**RE: Proposed Multi-Family Development  
Louise Berry Drive**

In response to your review comments on the referenced project dated March 9, 2021, we offer the following:

# PROPOSED MULTI-FAMILY CONDOMINIUM DEVELOPMENT

LOUISE BERRY DRIVE  
BROOKLYN, CONNECTICUT

STORMWATER BASIN DETAIL  
SCALE: 1"=30'

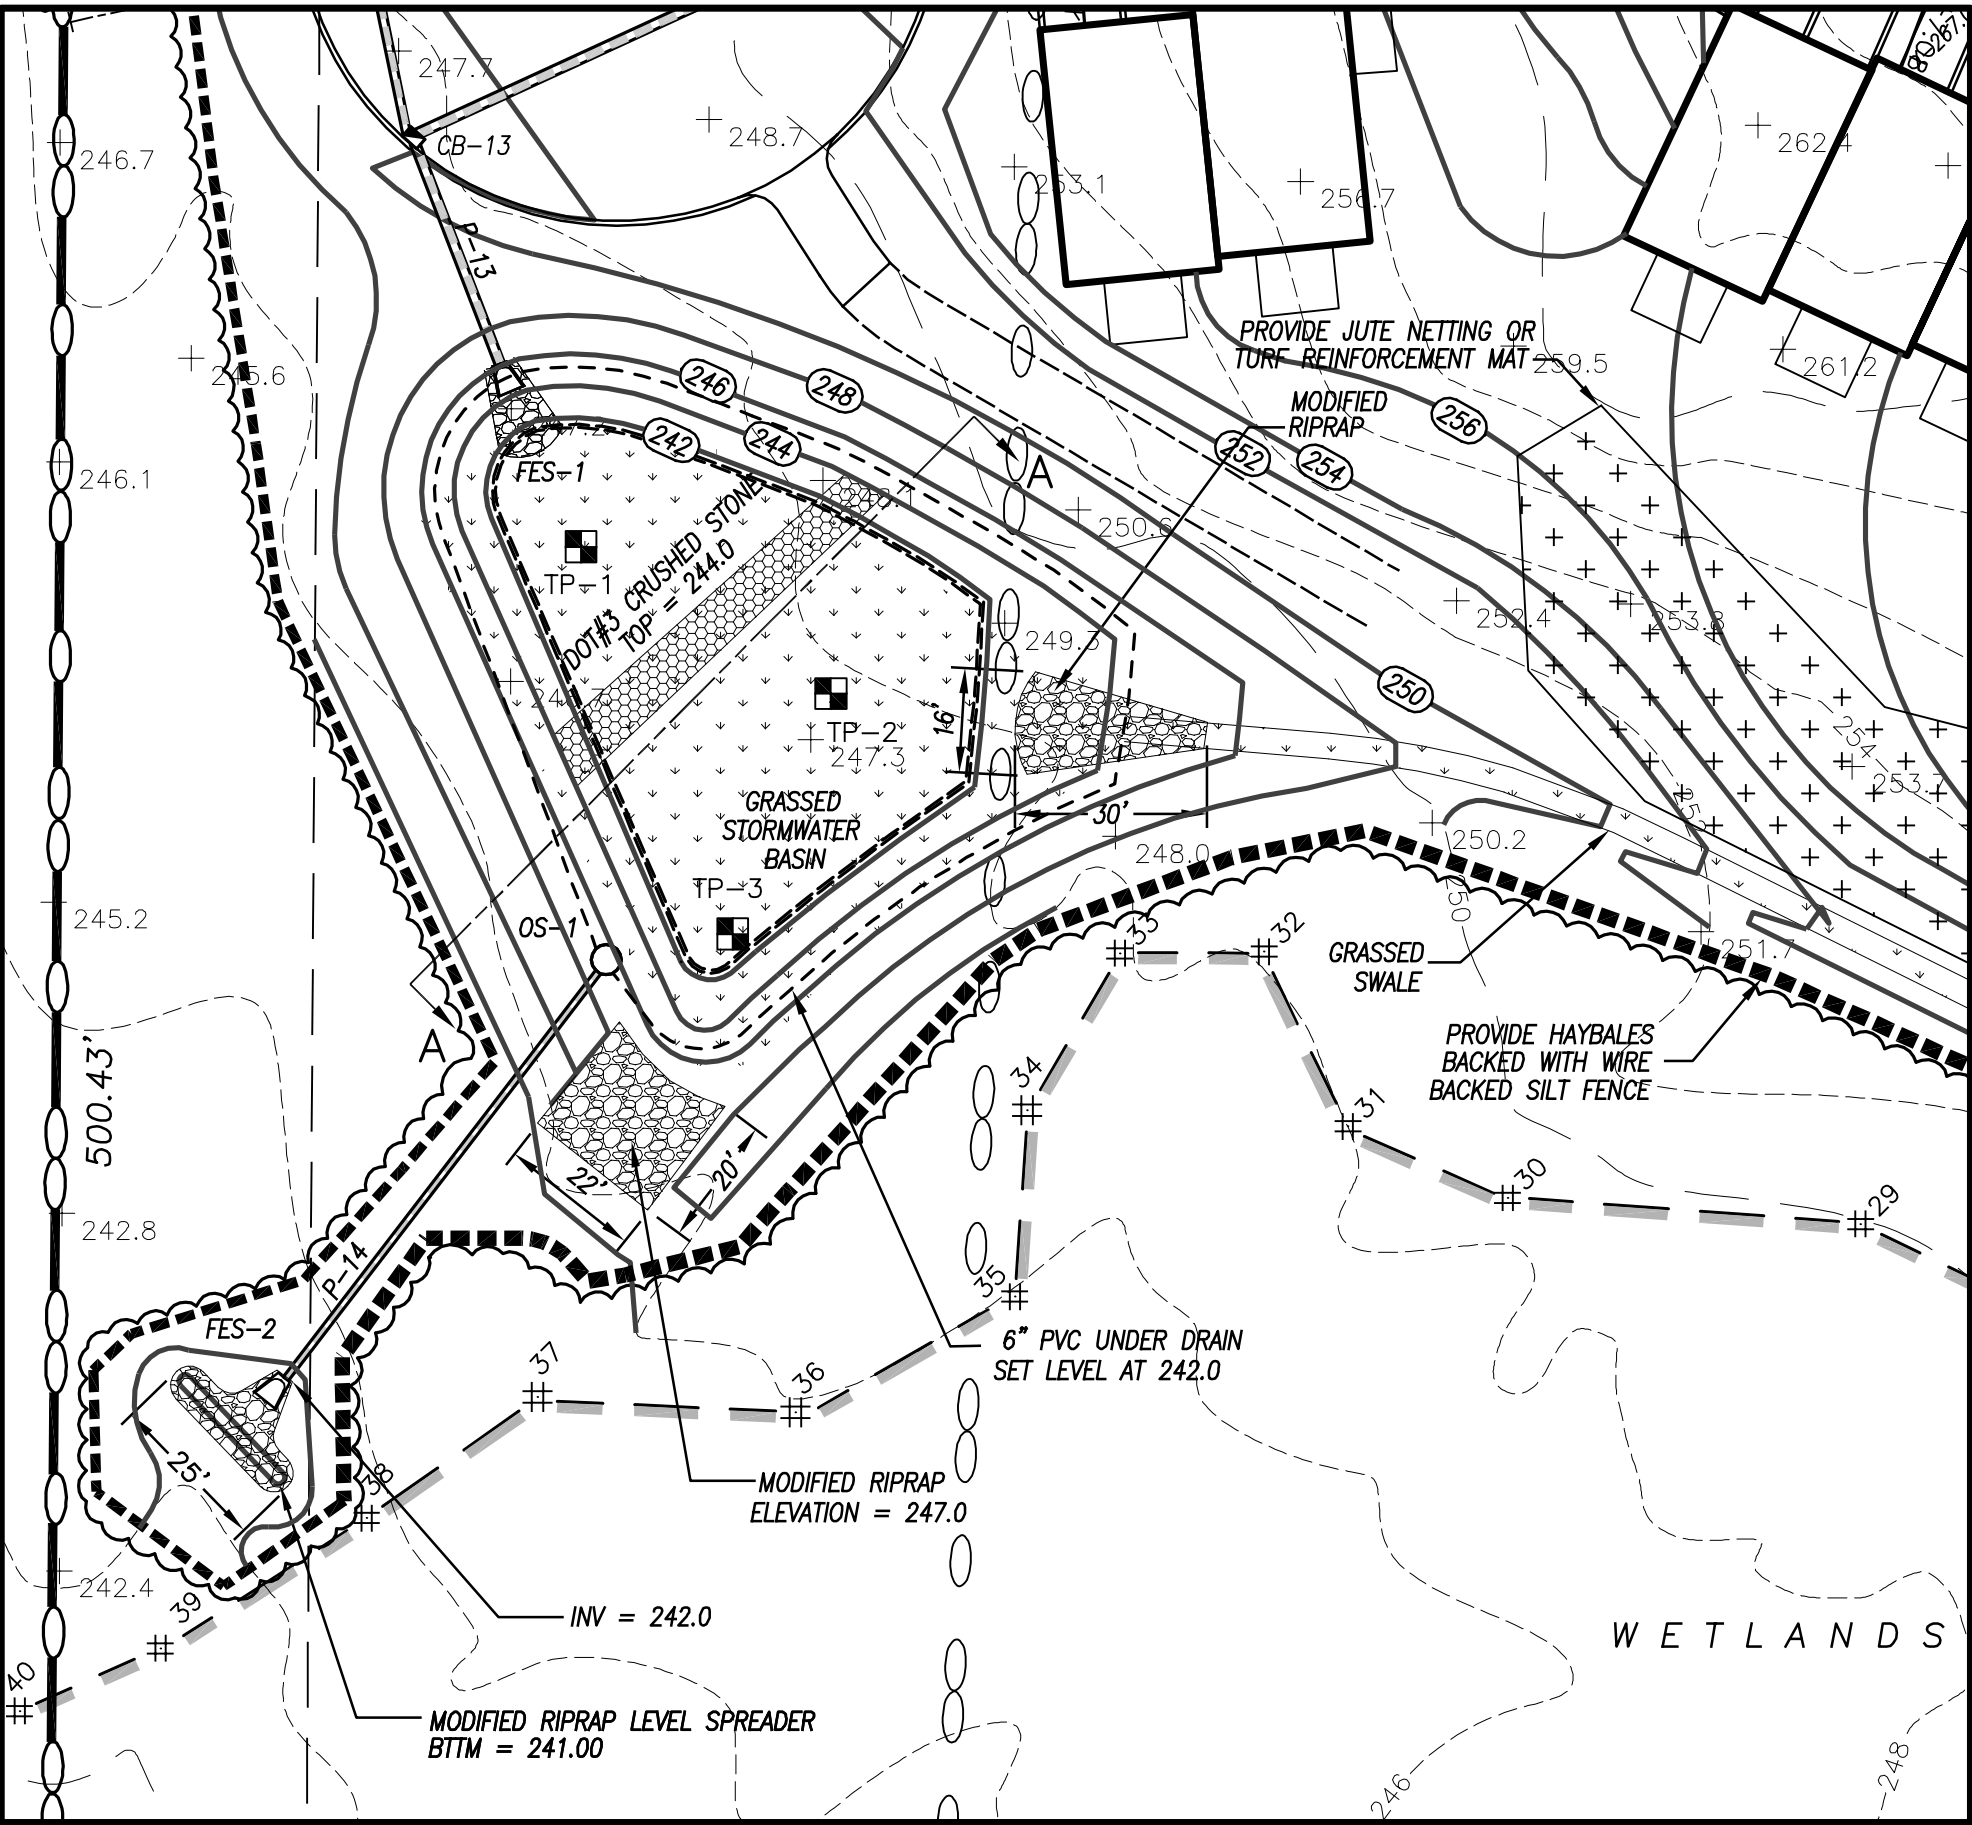
- The Detention Basin O&M Plan, Detail sheet 4 has been revised to state that the Condominium Association will be responsible for maintenance for perpetuity.

NOTE: THE CONDOMINIUM ASSOCIATION SHALL BE RESPONSIBLE FOR THE MAINTENANCE OF THE ENTIRE STORMWATER SYSTEM

TEMPORARY SEDIMENT TRAP DETAIL  
SCALE: 1"=30'

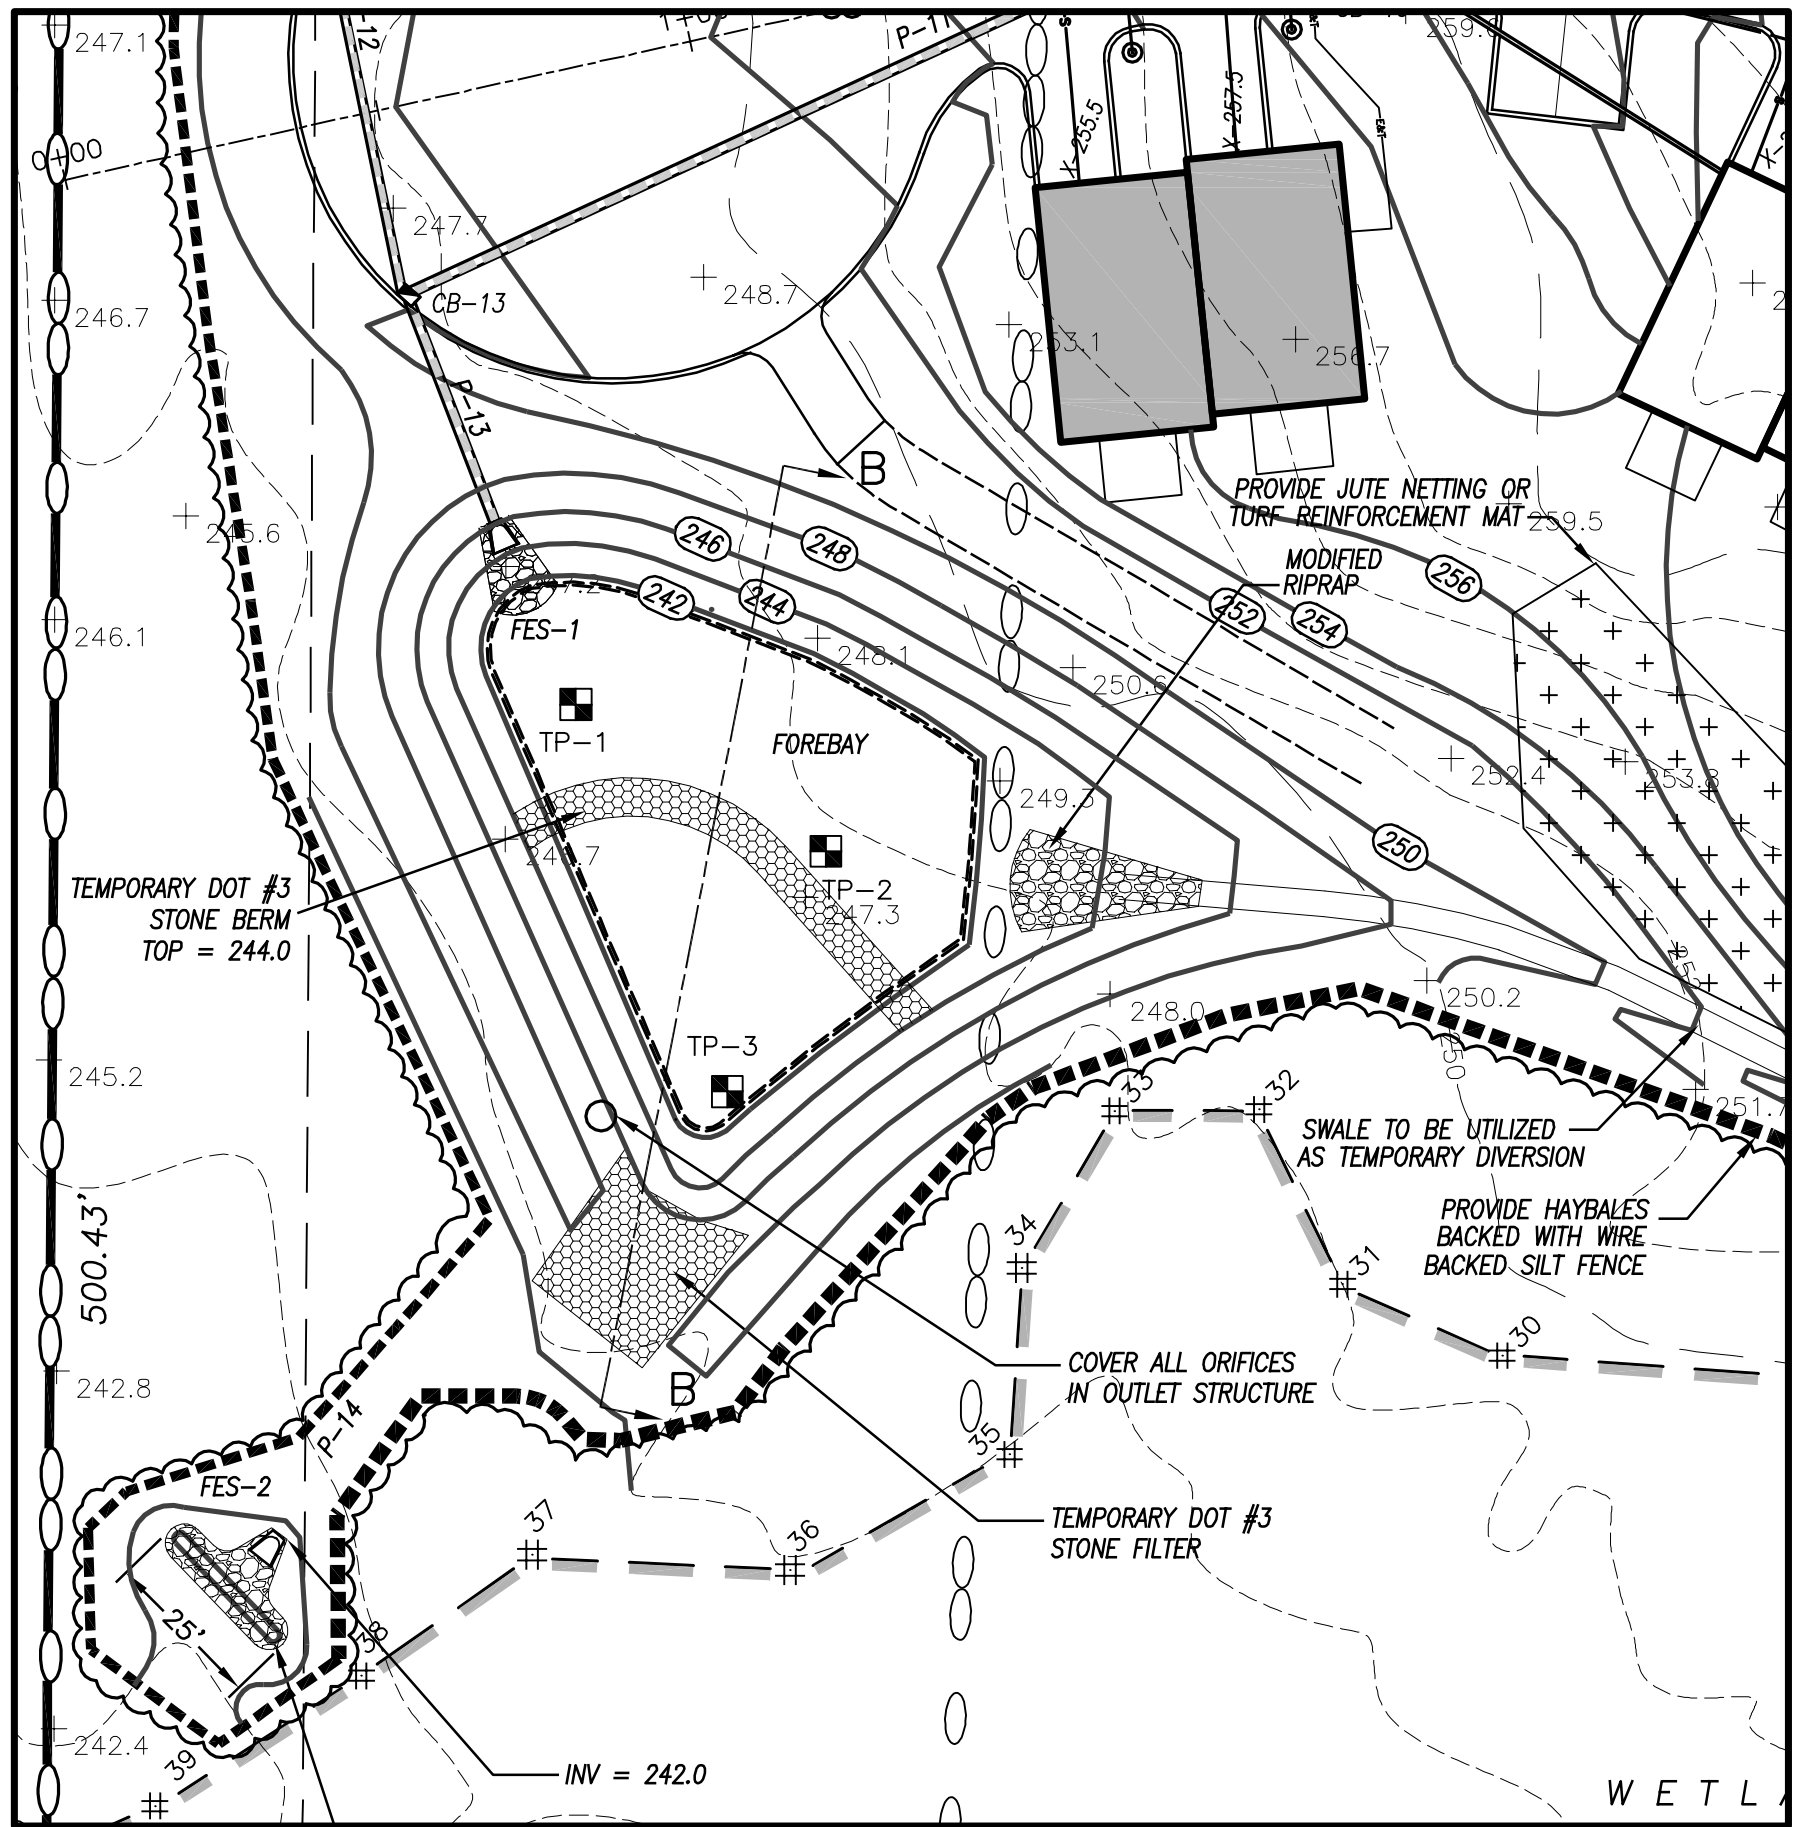
- A note regarding construction dates for the temporary sediment trap and swale has been added below the Temporary Sediment Trap detail.
